Noncompliant Weld Inspection Techniques

Line 114 Non Destructive Examination Final Report

Issue Date December 5, 2013

Weld 771 cited for indications of internal undercut from 12-24

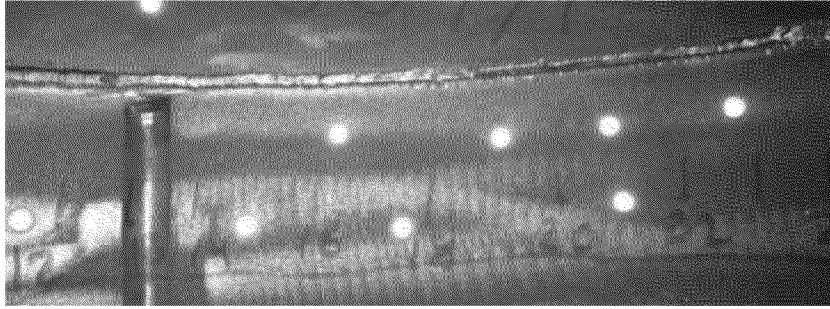
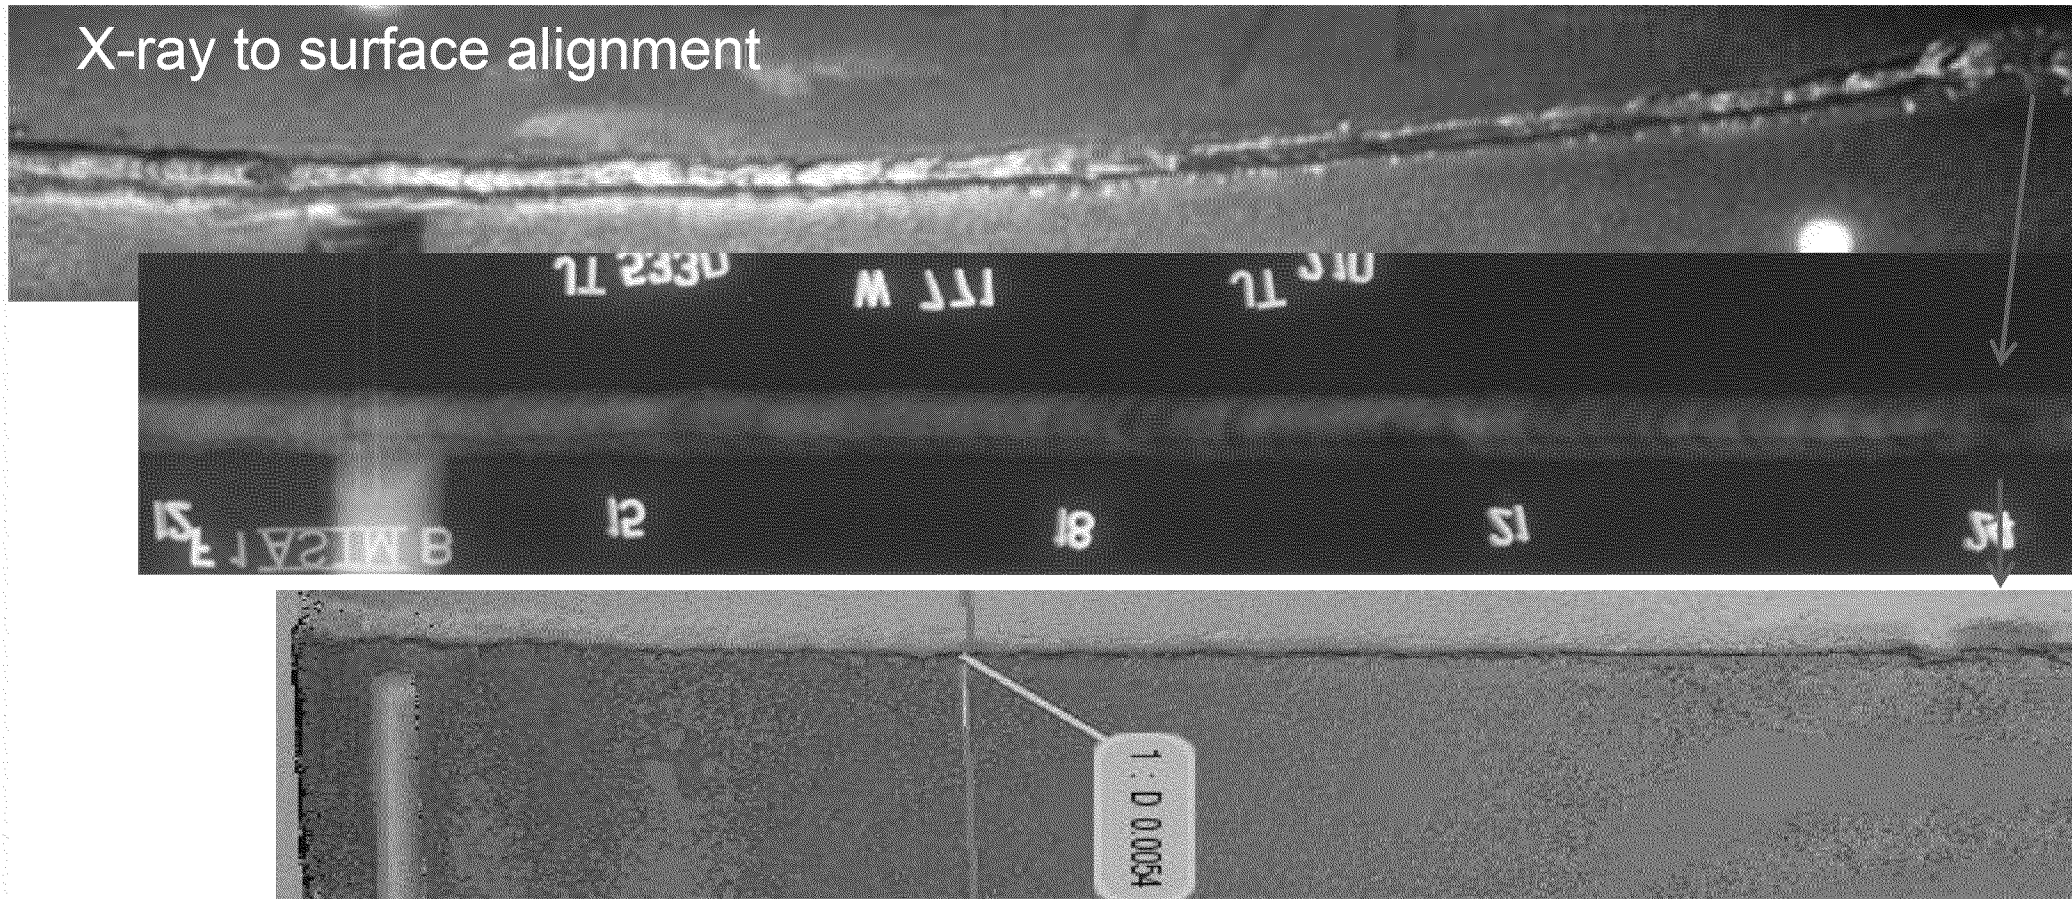
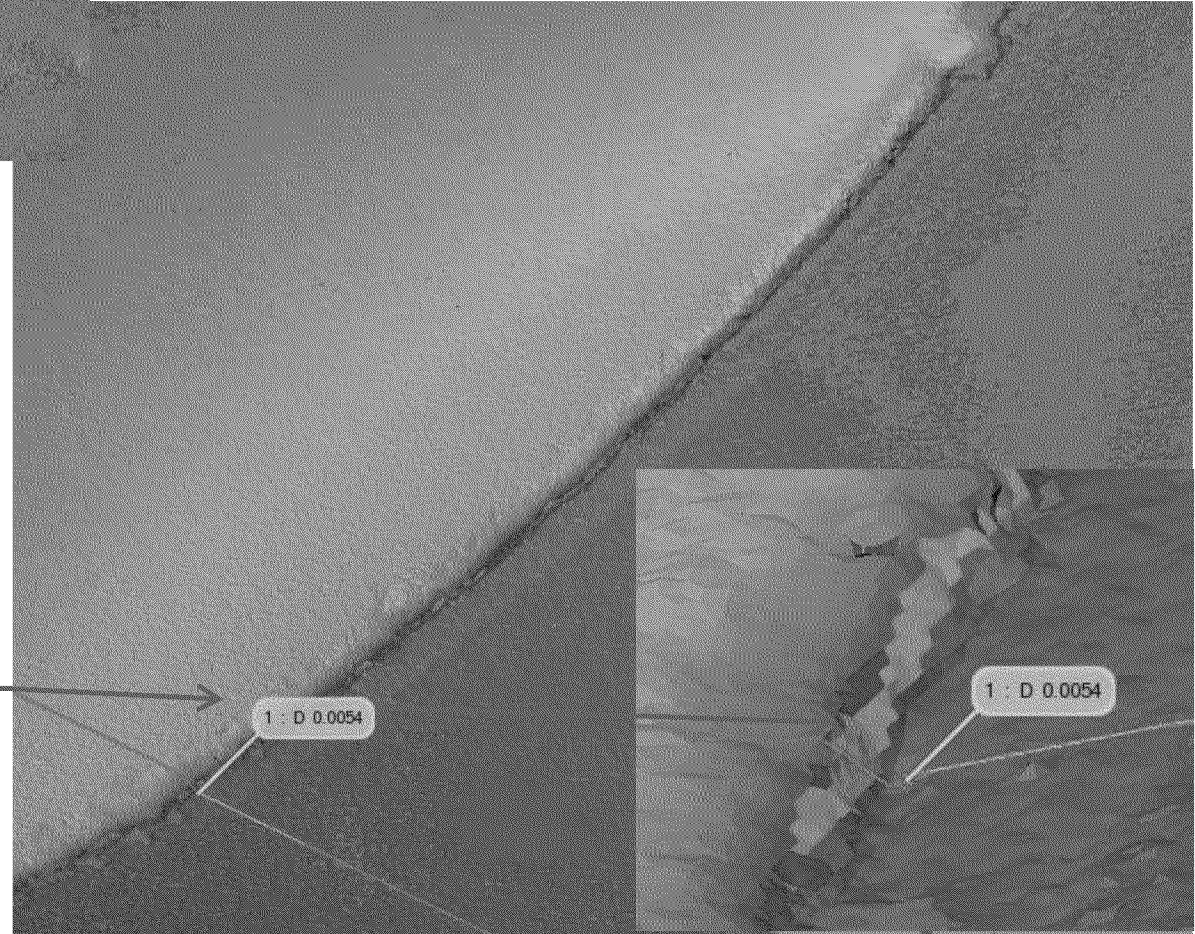
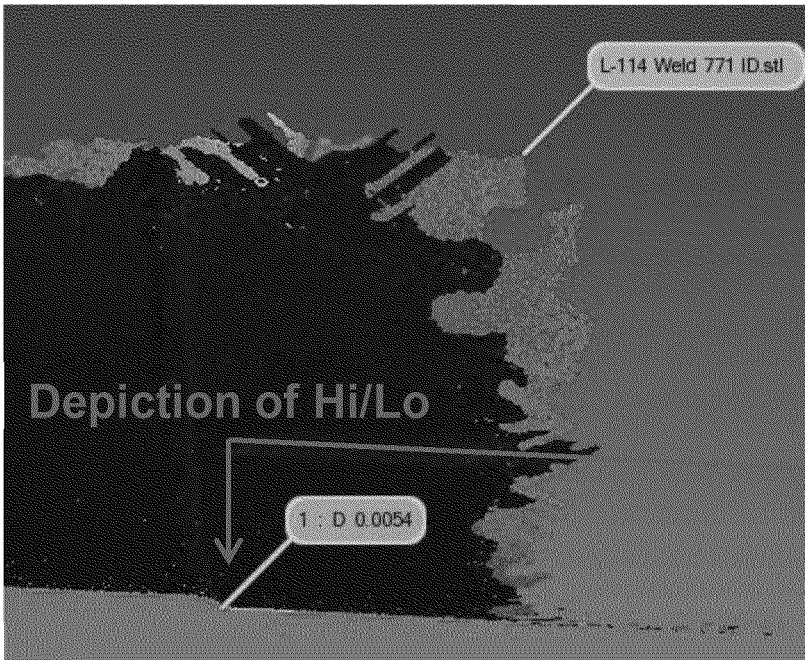
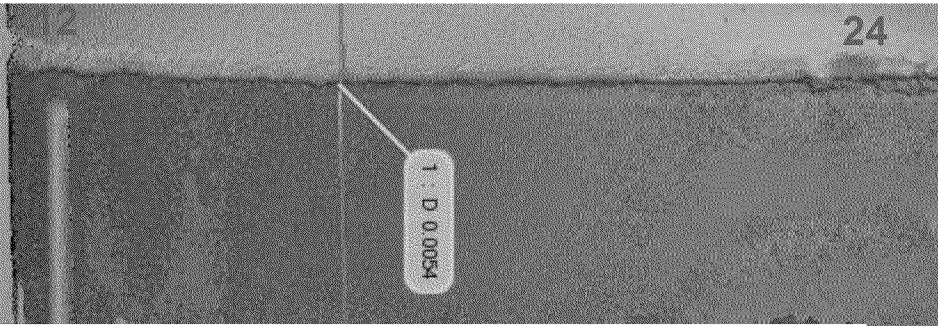
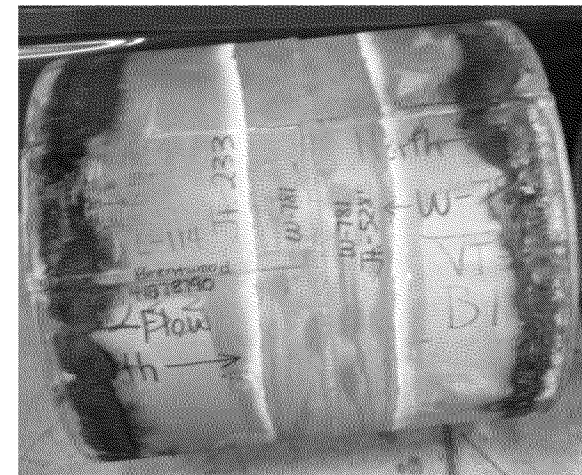
RT estimated depths of up to 0.008 inches

- Confirms indications are mostly diffraction effects on minor hi/lo condition with 0 UC
- Deepest region along length is 0.006 inches
- Weld is acceptable per API 1104

- * Confirms UC indication is diffraction/"shadowing" from high/low condition
- * Weld is acceptable per API 1104

Weld 781 cited for indications of internal undercut from 44-49

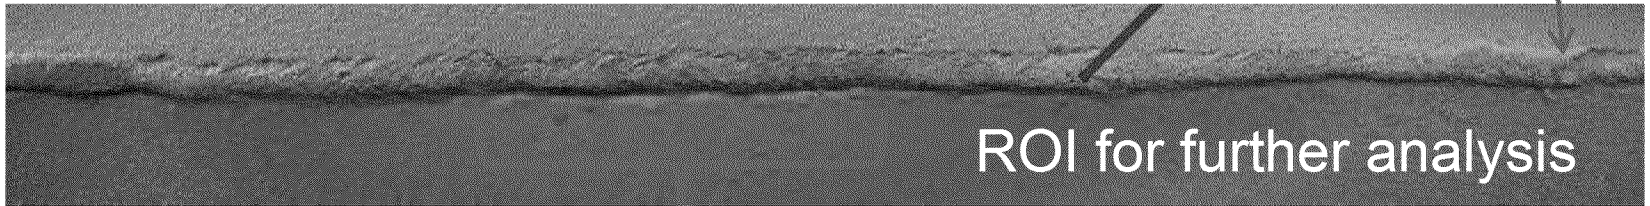
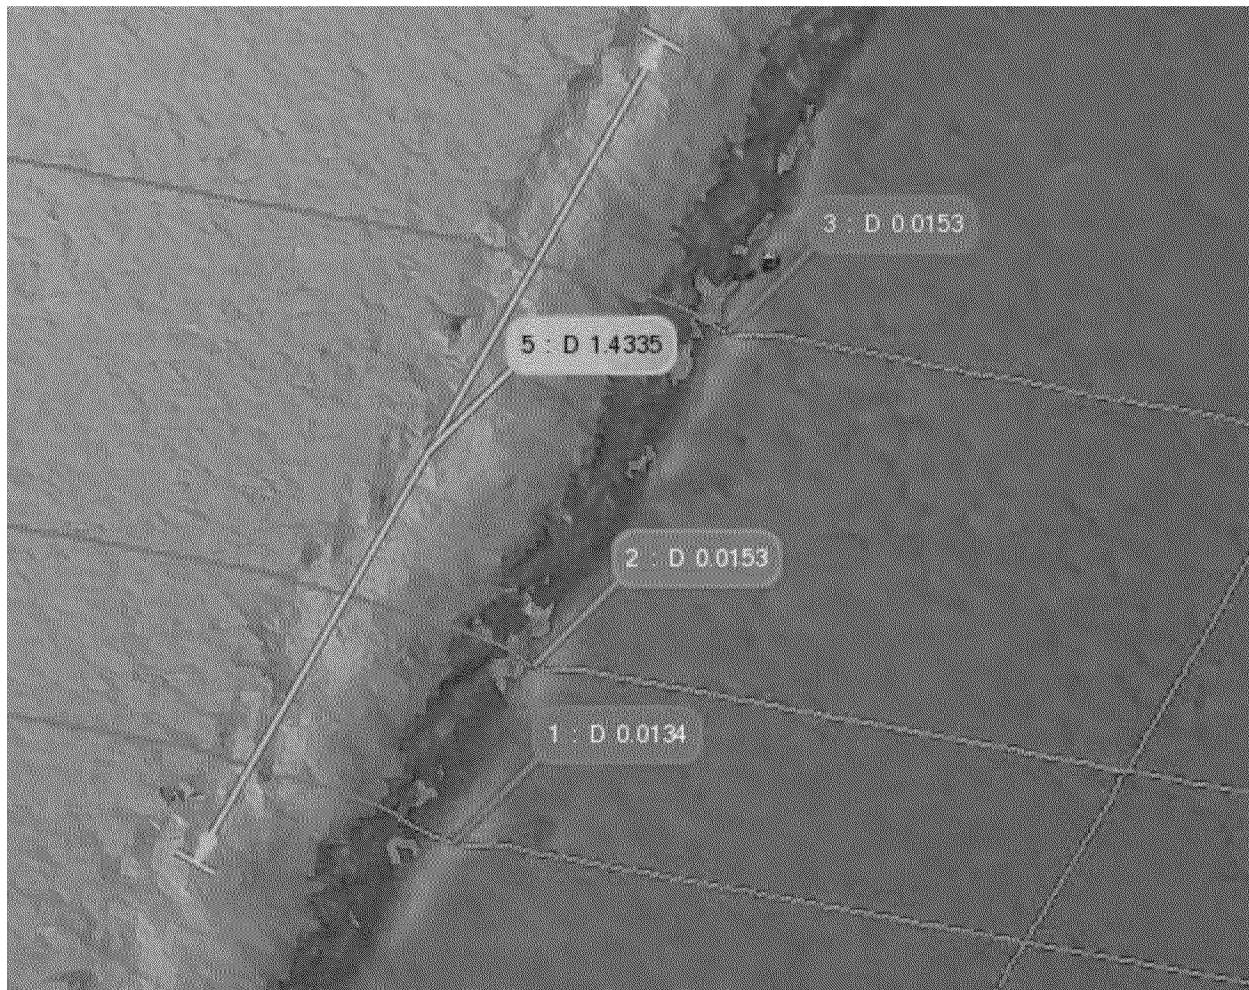
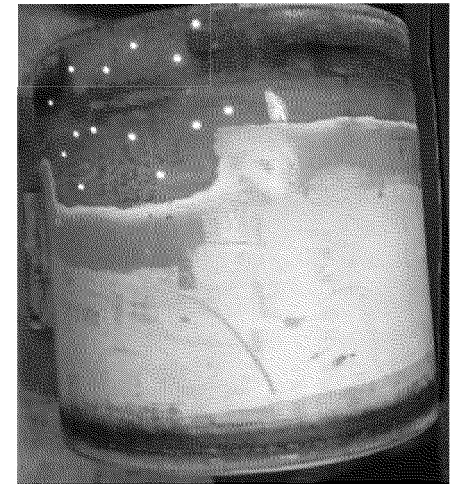
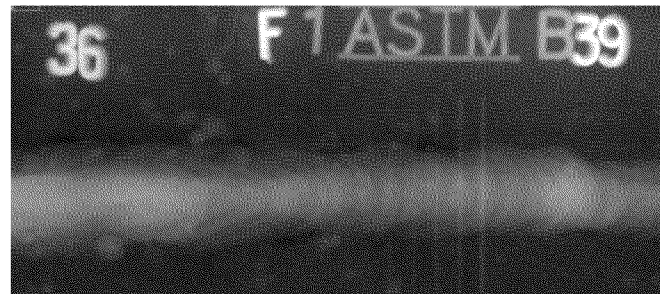
Confirms indications are mostly diffraction effects on minor hi/lo condition with 0 UC

Weld is acceptable per API 1104

- * Confirms UC indication is, in the majority, diffraction/"shadowing" from high/low condition with less than 2 inches of up to 0.015 inches deep IUC
- * Weld is acceptable per API 1104

Weld 738 cited for indications of external undercut from 36-42

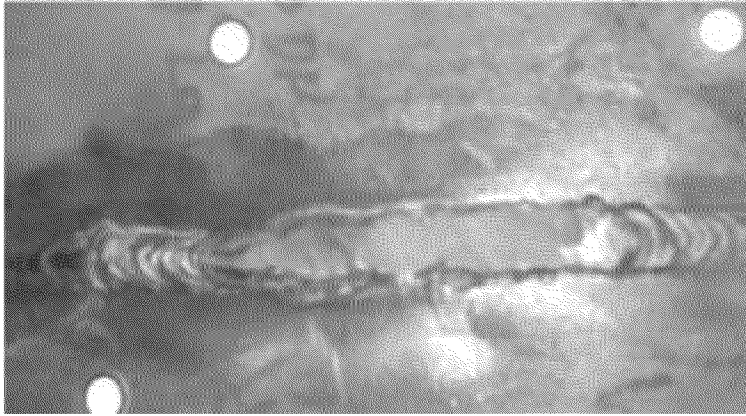
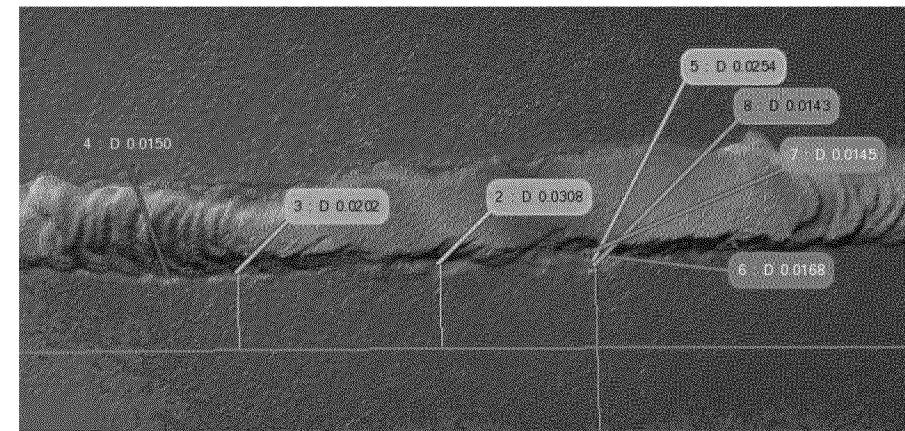
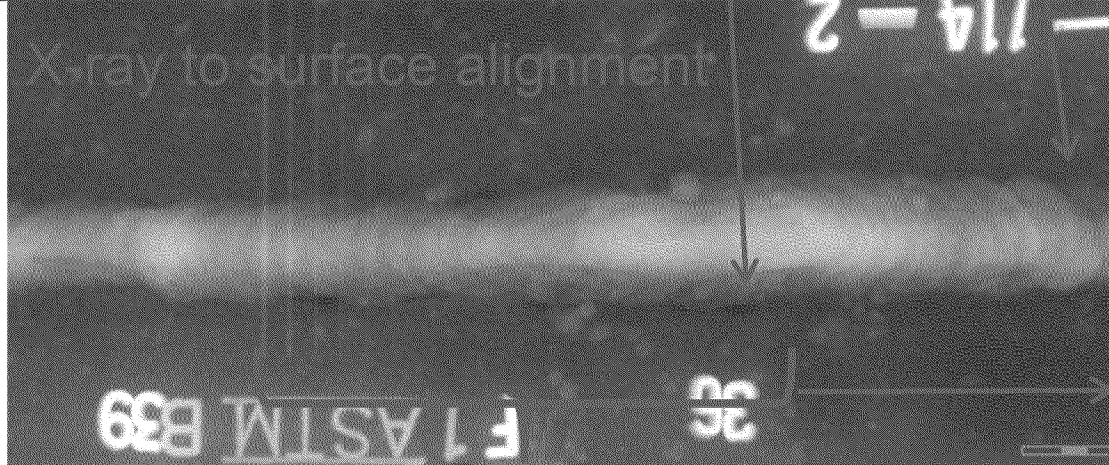
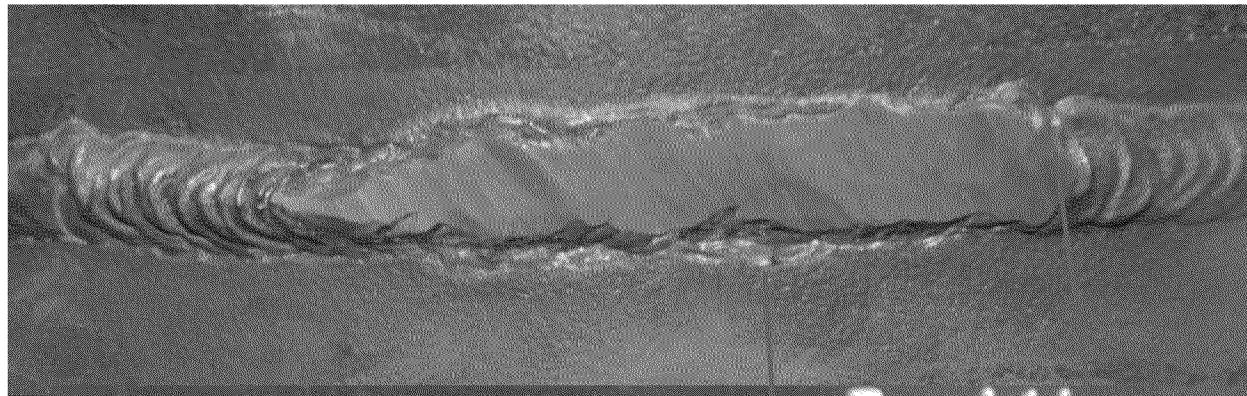
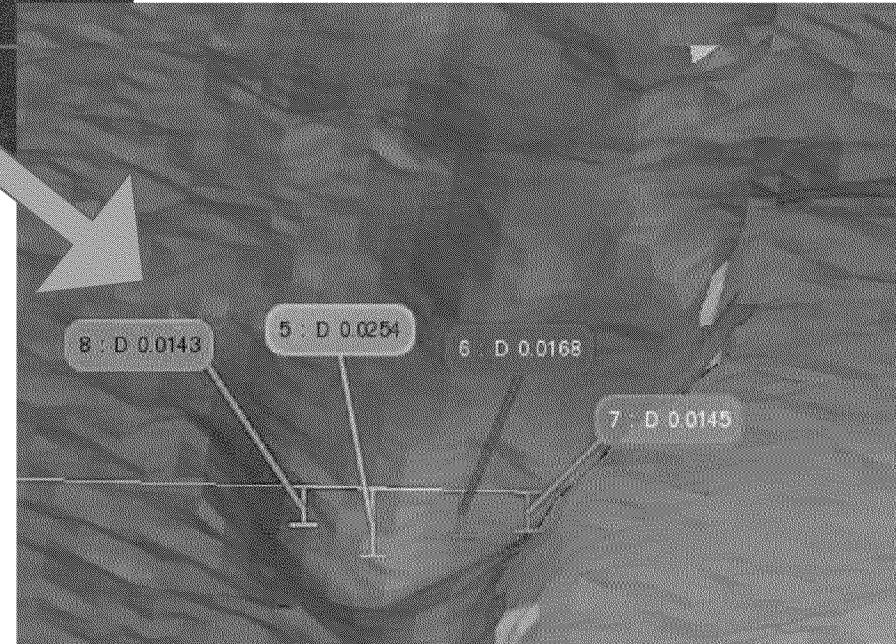
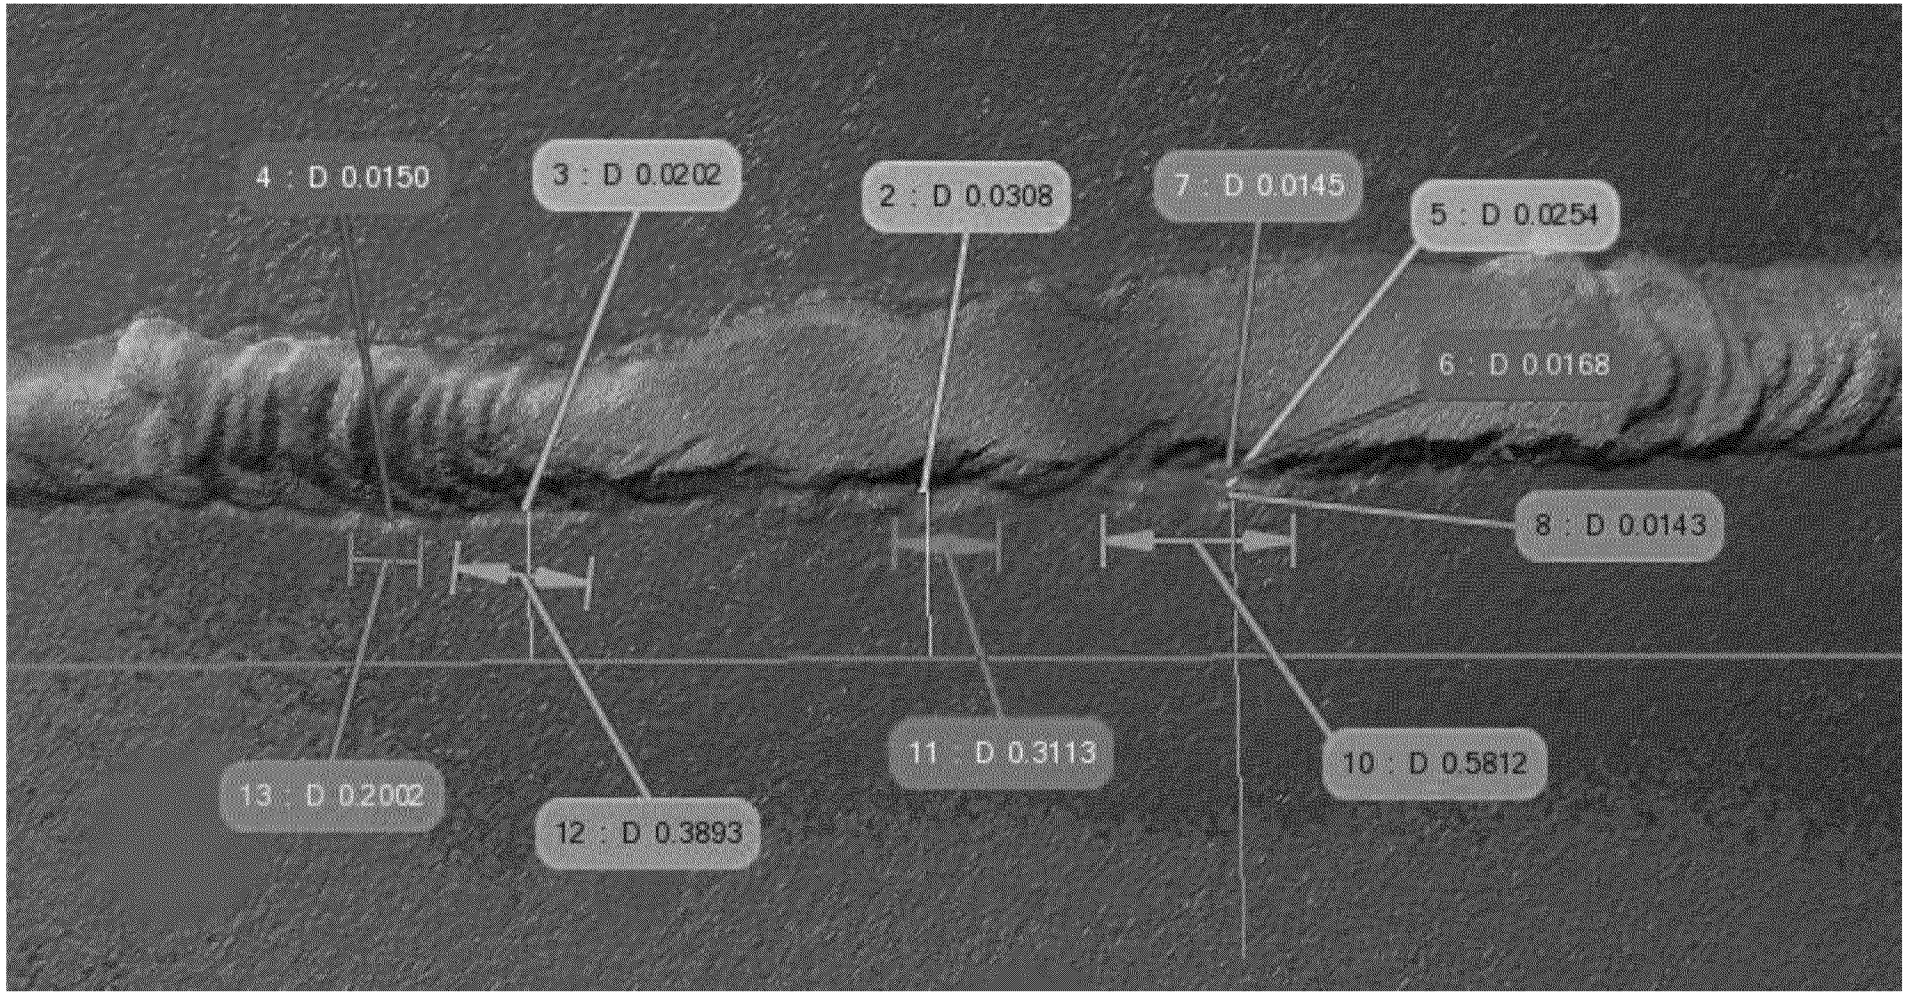
RT estimated depths of up to 0.030 inches

External undercut identified up to 0.030" deep

Sum of UC lengths < 1.5"

Weld is acceptable per API 1104
